TRANSMITTAL COVER SHEET

DATE: 21 June, 2024
TO: ALL PLAN HOLDERS OF RECORD
FROM: HUNTER SWATEK, AIA, PROJECT MANAGER
PROJECT: RAINBOW CITY RECREATION CENTER
GMC PROJECT NO. ABHM230021
RE: ADDENDUM NO. 3 AND
ACKNOWLEDGEMENT OF RECEIPT OF ADDENDUM NO. 3

ADDENDUM NUMBER 03

**PROJECT: RAINBOW CITY RECREATION CENTER
GM&C PROJECT NO. ABHM230021**

SECTIONS
S3.04

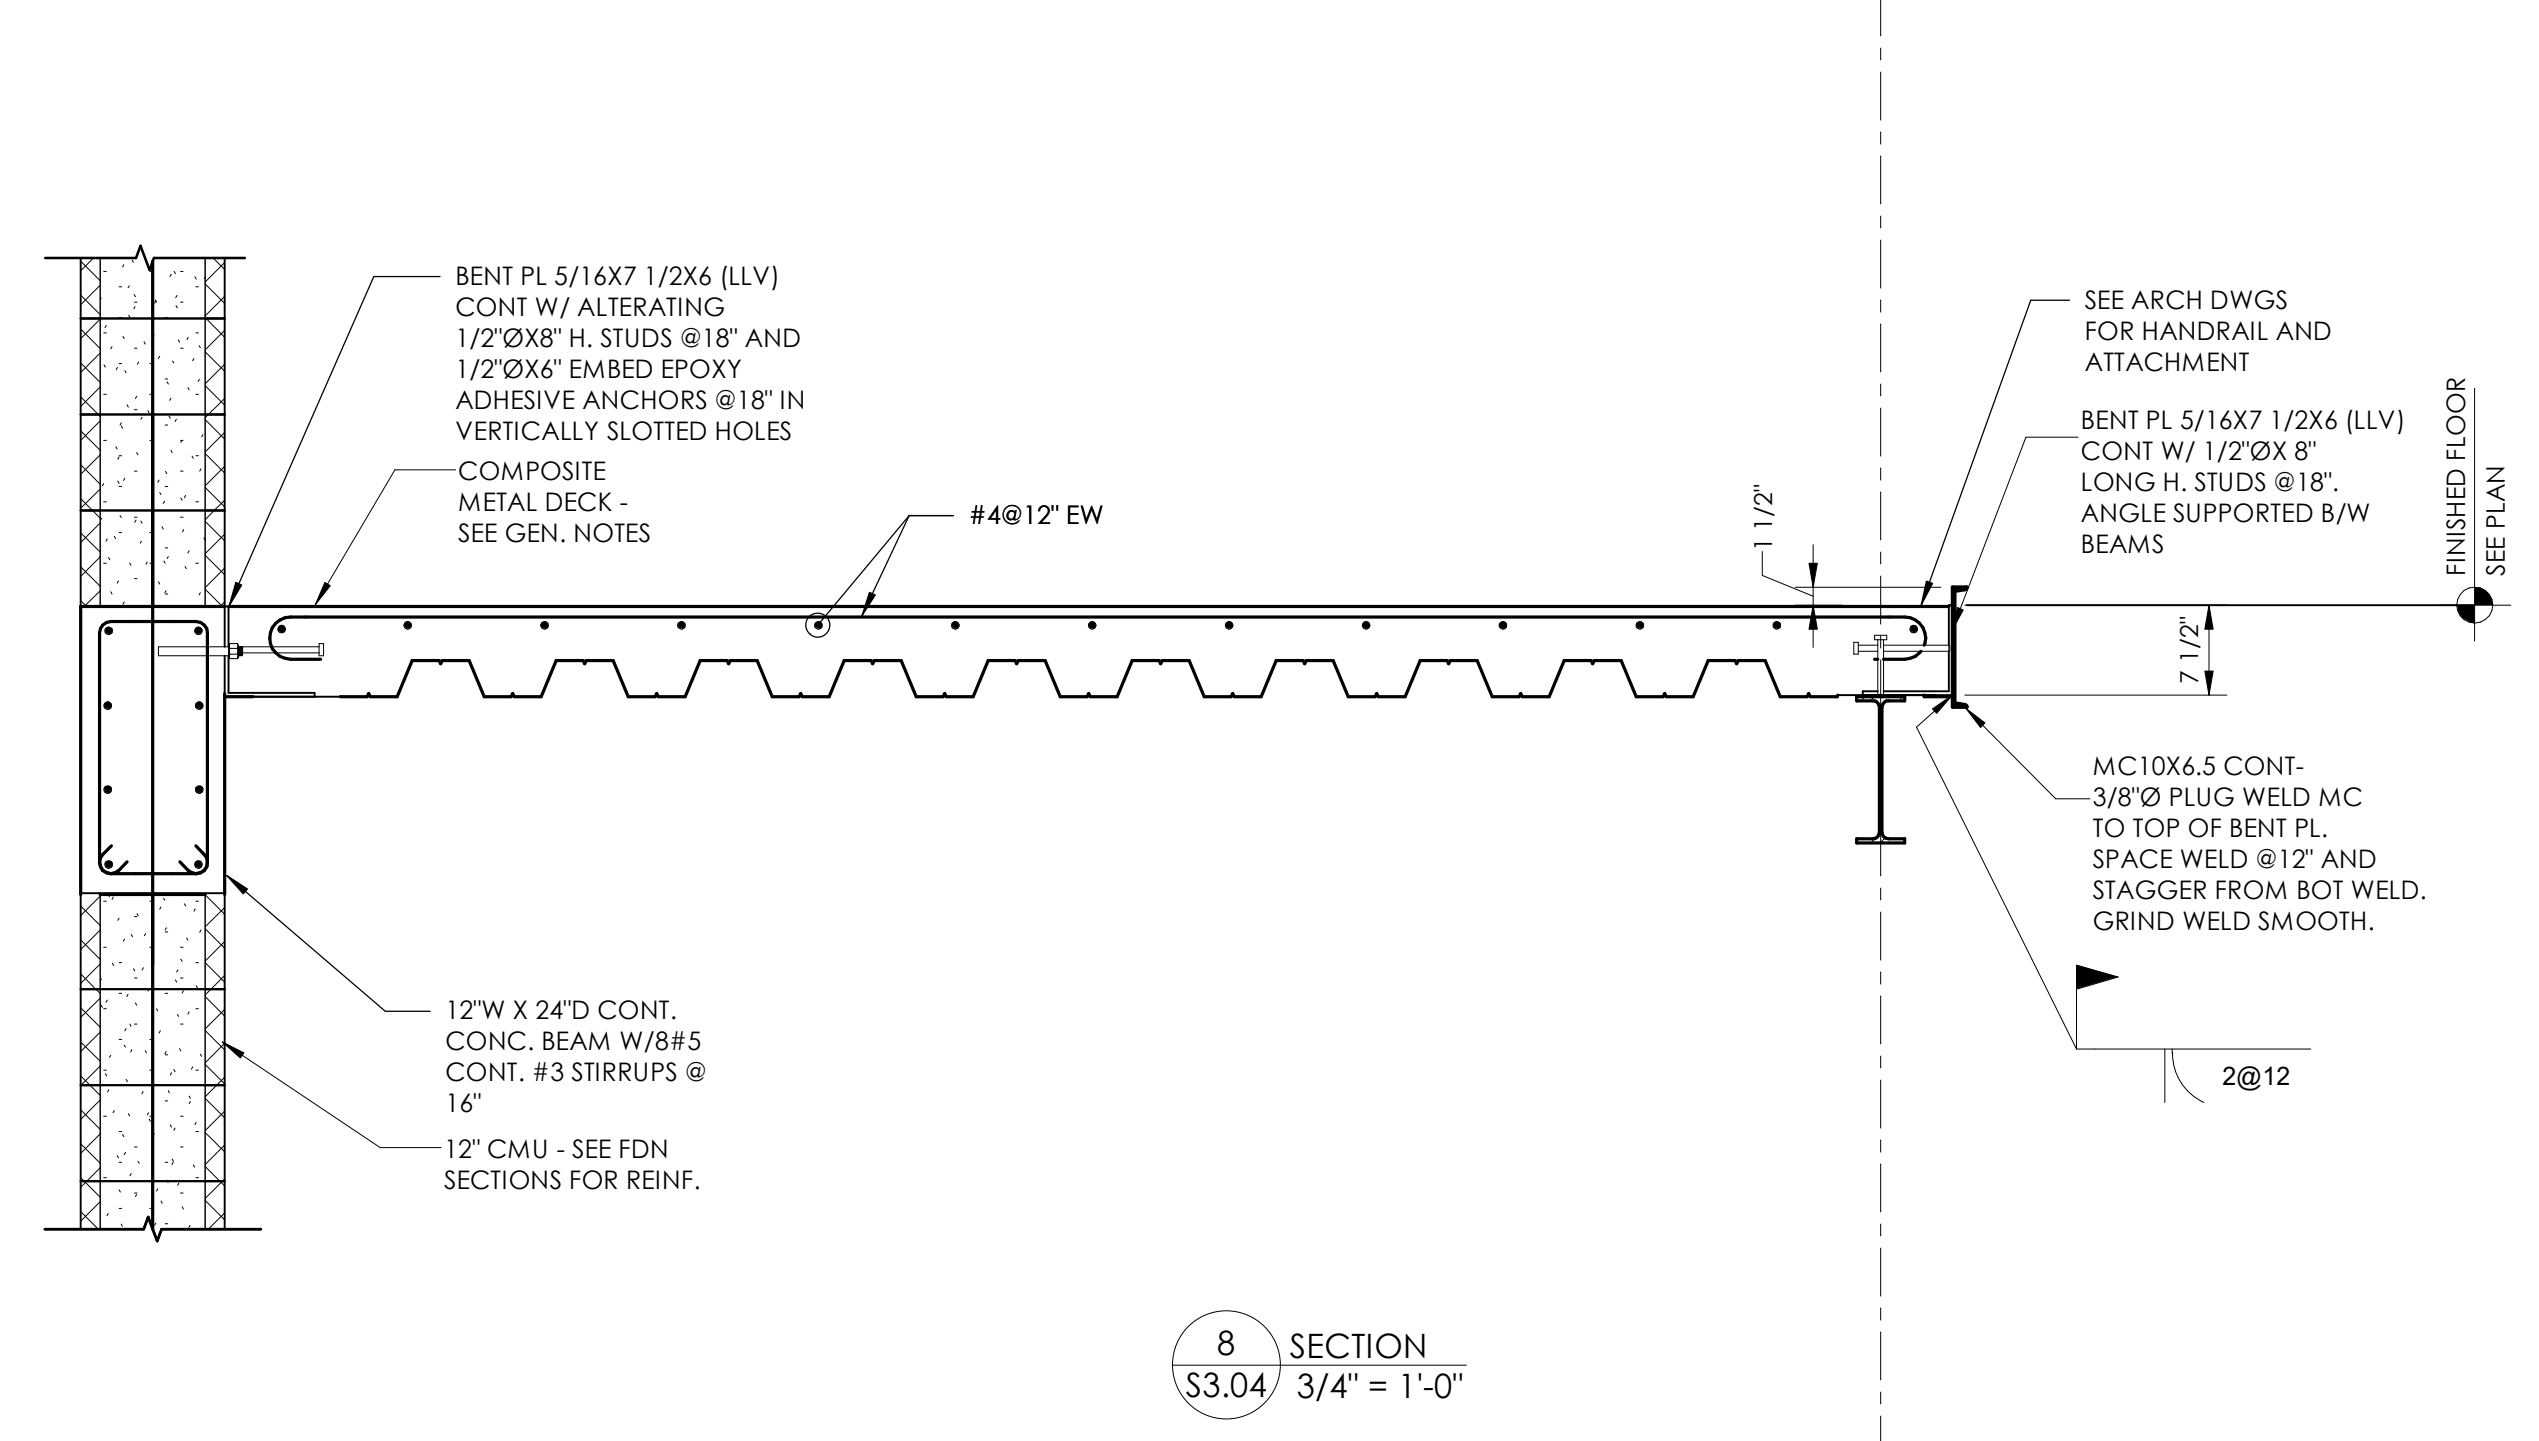
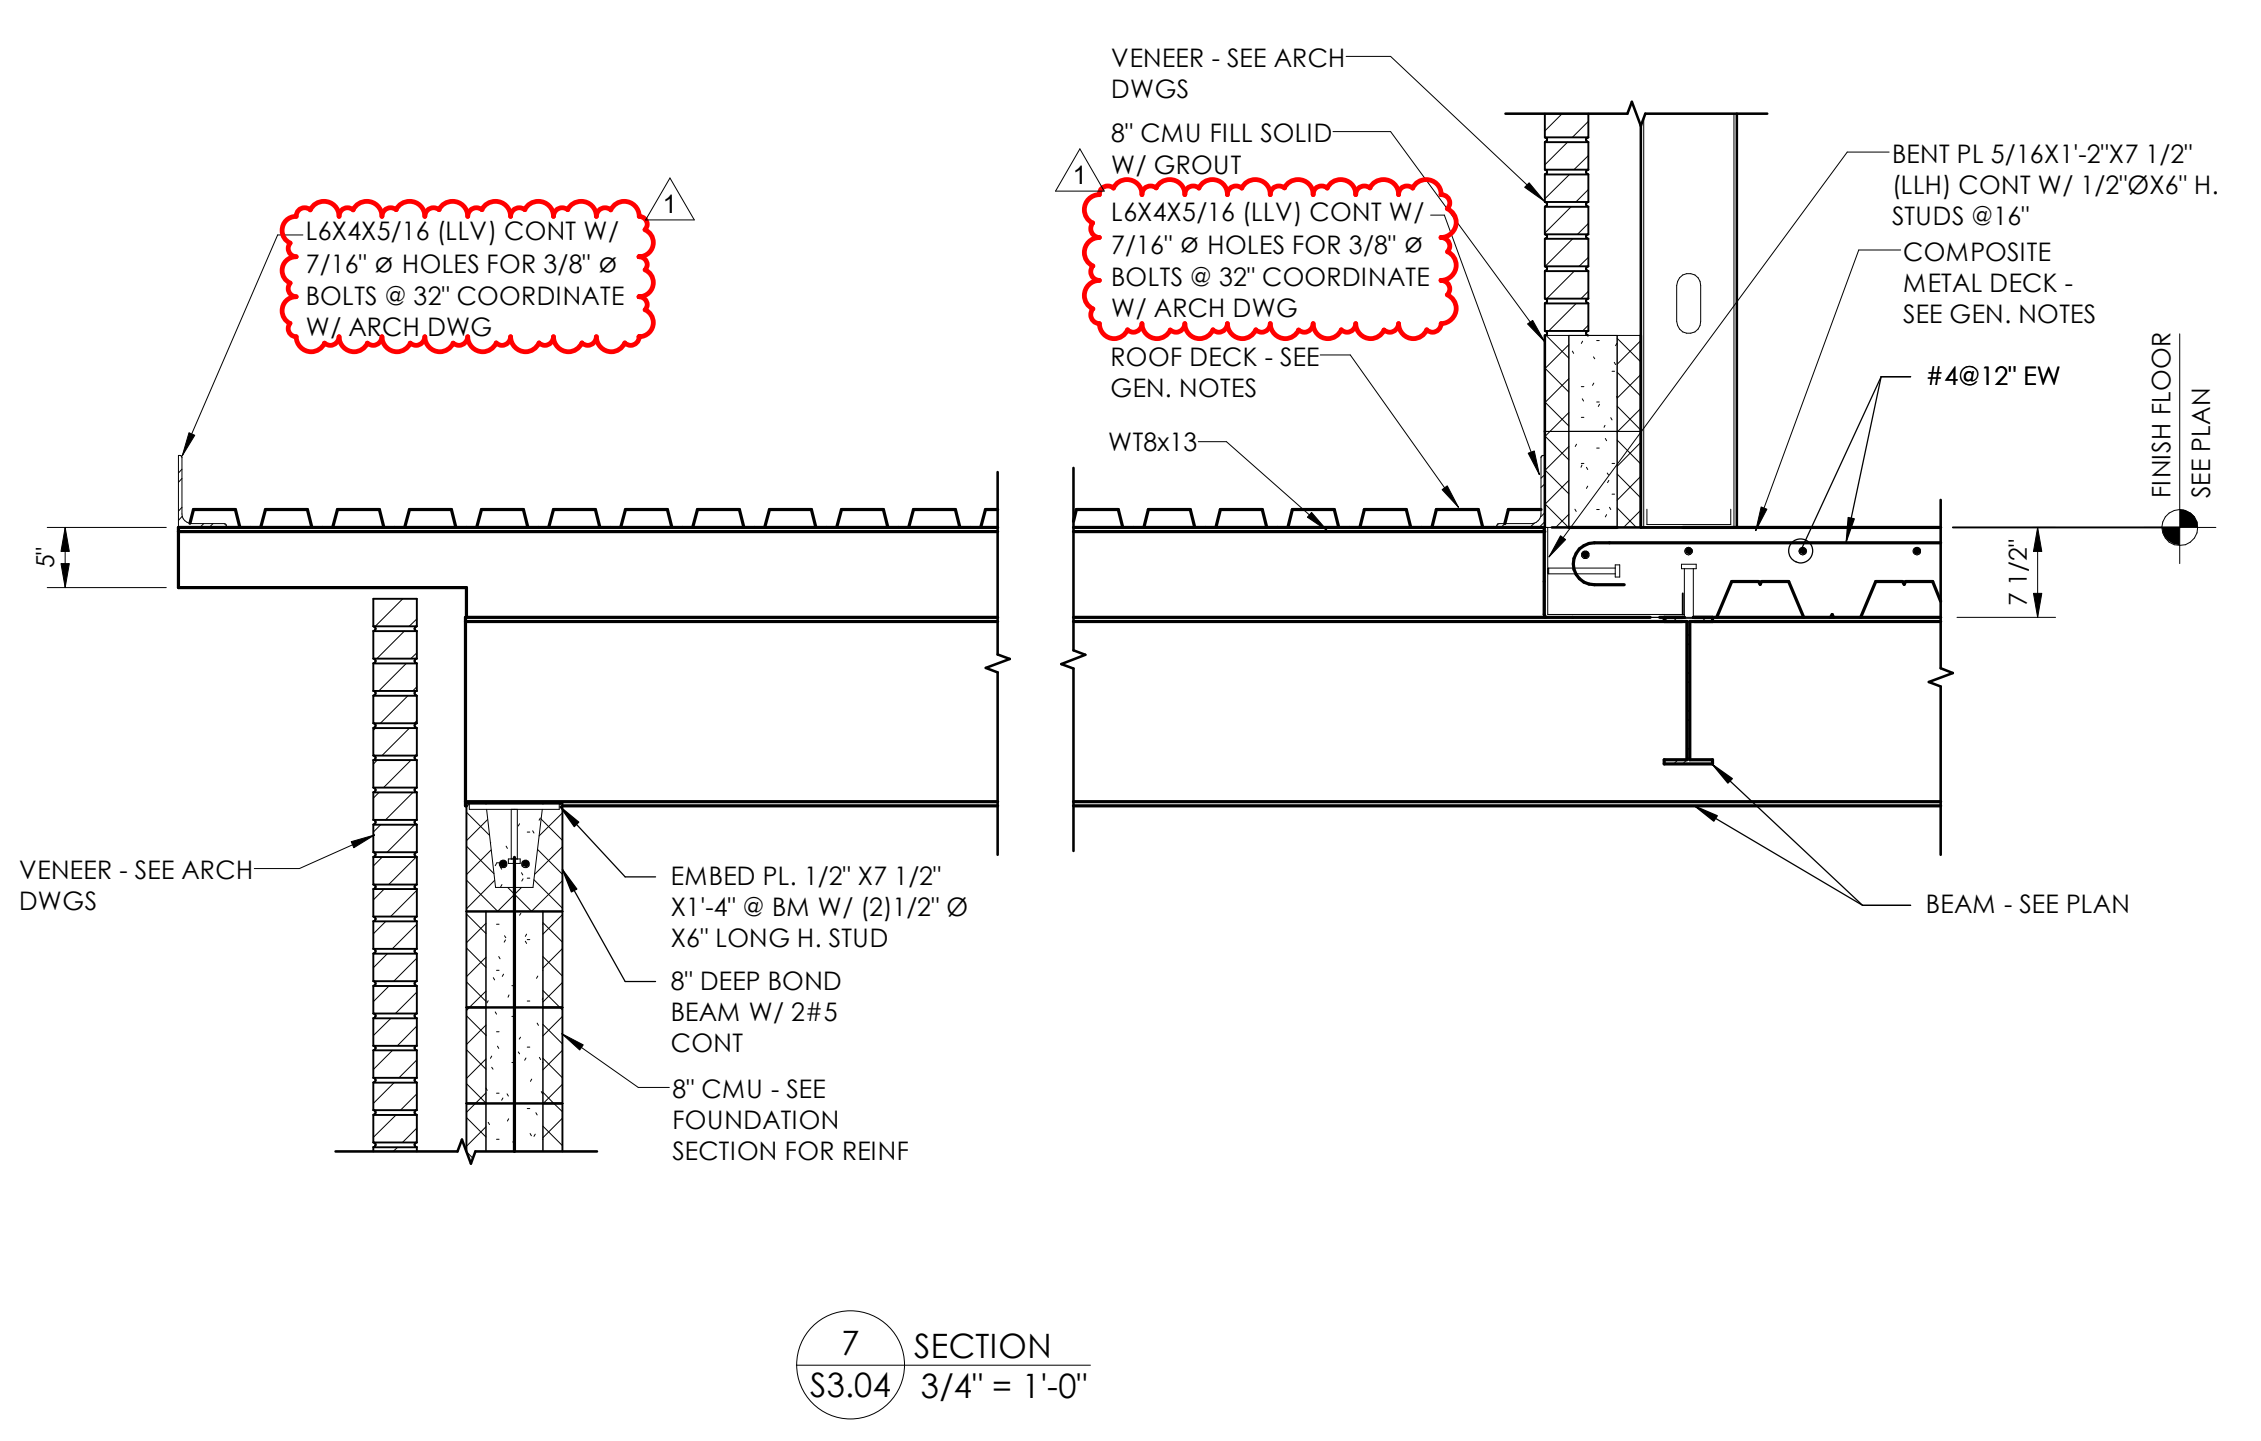
- a. ADDED Sections
- Y. **S3.02** – Sections
 - a. REVISED Angle size
- Z. **S3.03** – Sections
 - a. REVISED Angle size
- AA. **S3.04** – Sections
 - a. REVISED Sizes
